INDEPENDENT EXPERT ADVISORY PANEL FOR MINING

IEAPM Advice on Metropolitan Coal EP for LW311-316

Stage 1: LW 311 and LW312

Figure 1 shows the location of longwall panels, swamps and tributaries relevant to this advice.

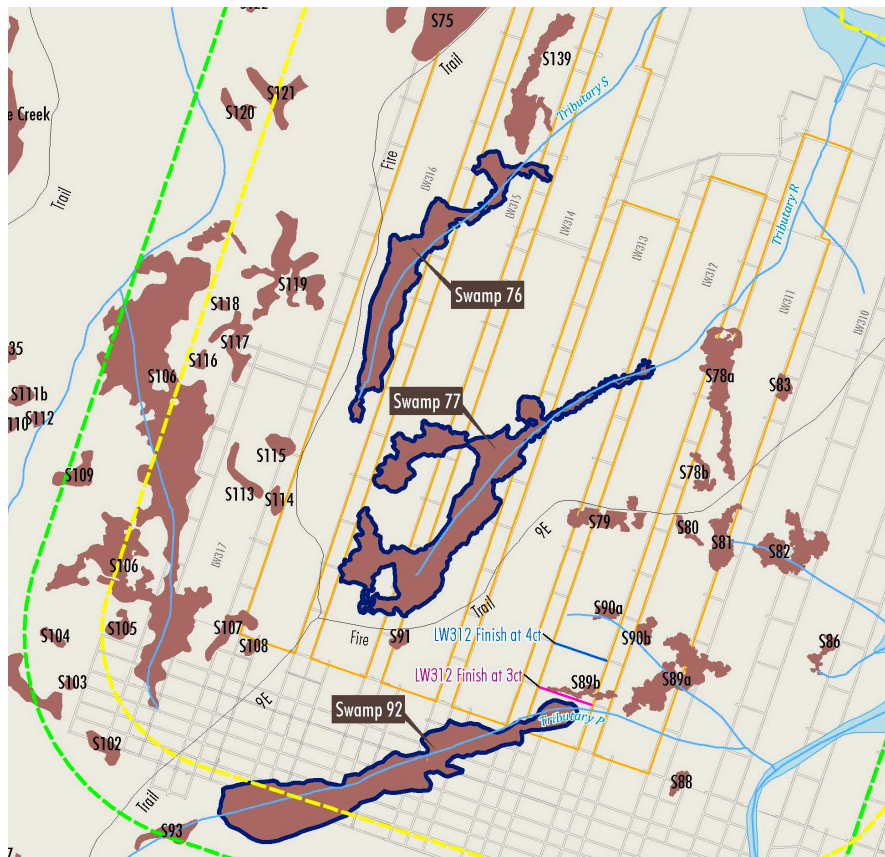
1. LW 311 does not directly mine under Swamps 76, 77 and 92 and, therefore is exempt from Condition 4 of Schedule 3 of the approval conditions.
2. Tributary R, which originates in Swamp 77, runs longitudinally over approximately 350m of inbye end (starting end) of LW311 (noting as shown in Figure 1 that this starting point has been moved outbye from its original planned position).

6. Tributary P, which originates in Swamp 92, runs transversally across the planned outbye end (finishing end) of LW311.
7. Based on total (cumulative) predicted valley closure across Tributary P due to the extraction of LW311 and adjacent longwall panels, cracking of the watercourse bed sufficient to result in complete loss of pool water and subsurface water flow is very unlikely.

As shown in Figure 1, a very minor portion of Swamp 77 and a significant portion of Swamp 92 overlie LW312. There is a range of matters that need further consideration before the Panel can finalise its advice on the EP for LW312. These include but are not limited to:

1. There is general agreement amongst key stakeholders that Swamp 92 is particularly significant but the stand-off distance of LW312 from Swamp 92 (130 m or 260 m) is not agreed (noting also that the EP will need to be revised to reflect a similar stand-off distance for LW313).
2. There is no general agreement amongst key stakeholders yet as to the significance of Swamp 77 and this has implications for whether LW312 can mine under and adjacent to Swamp 77 or whether it will need to stand-off from it. If Swamp 77 is considered significant, careful consideration has to be given to the implications for the mine plan if longwall mining also has to stand-off from this swamp.
